YELLOW CREEK STATE PARK DAM
NDI I.D. NO: 282

PHASE I INSPECTION REPORT
NATIONAL DAM INSPECTION PROGRAM

D'APPOLONIA CONSULTING ENGINEERS
10 DUFF ROAD
PITTSBURGH, PA. 15235
SEPTEMBER 1978

YELLOW CREEK STATE PARK DAM
GENERAL PLAN
FIELD INSPECTION NOTES
FIELD INSPECTION DATE: 9-1-78

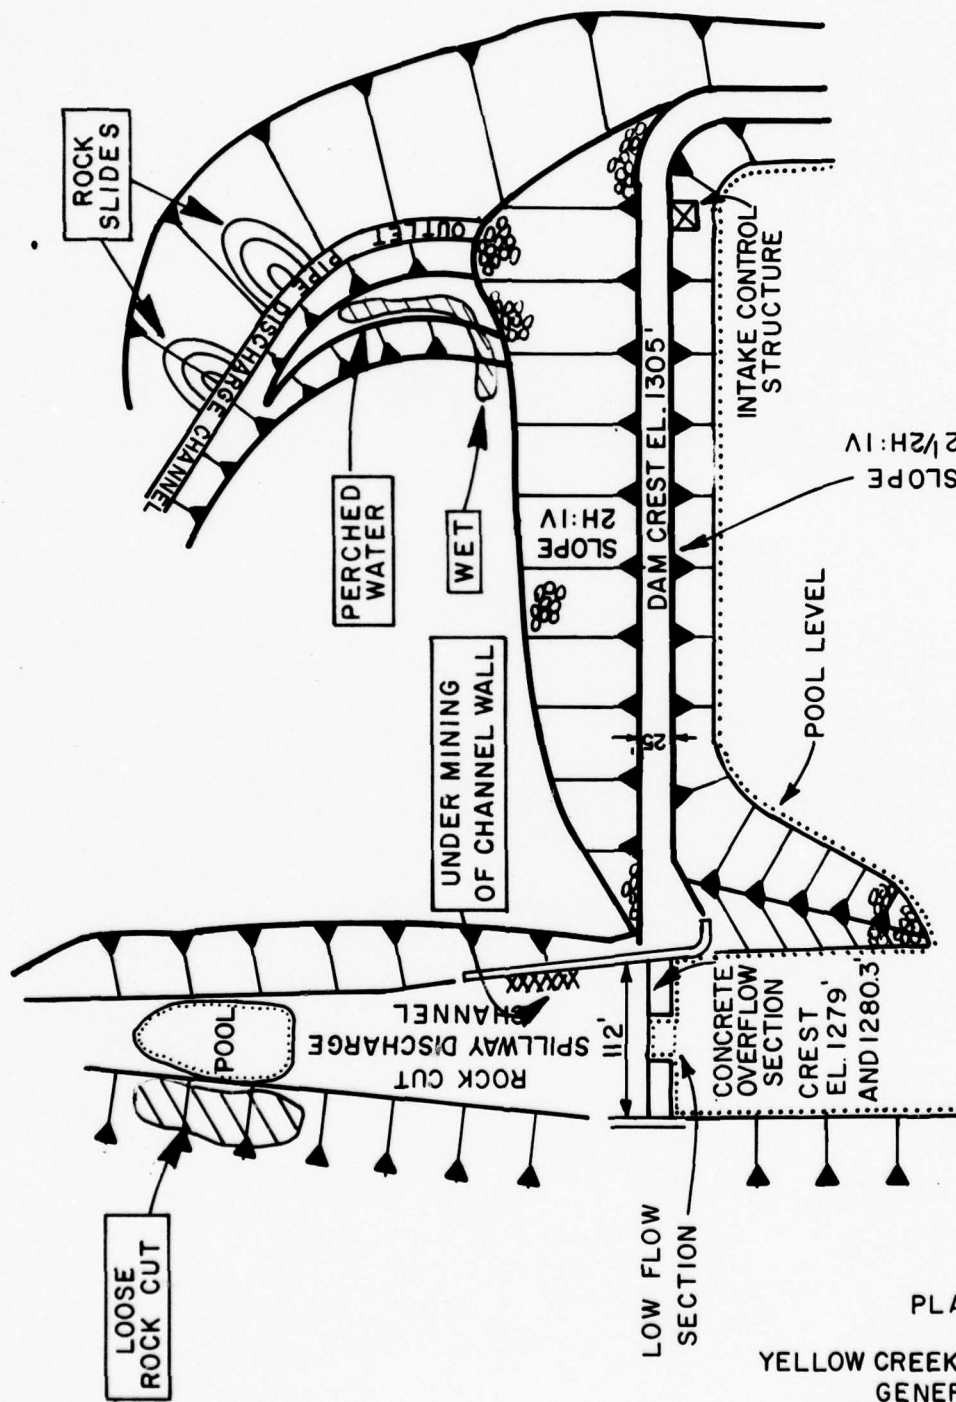
The specific observations are illustrated in Plate 14 and in the photographs in Appendix C.

In general, the condition of the dam is considered to be good. Only one wet area was observed, located on a bench on the left side of the outlet works discharge channel. No seepage appeared to be associated with this wet area.
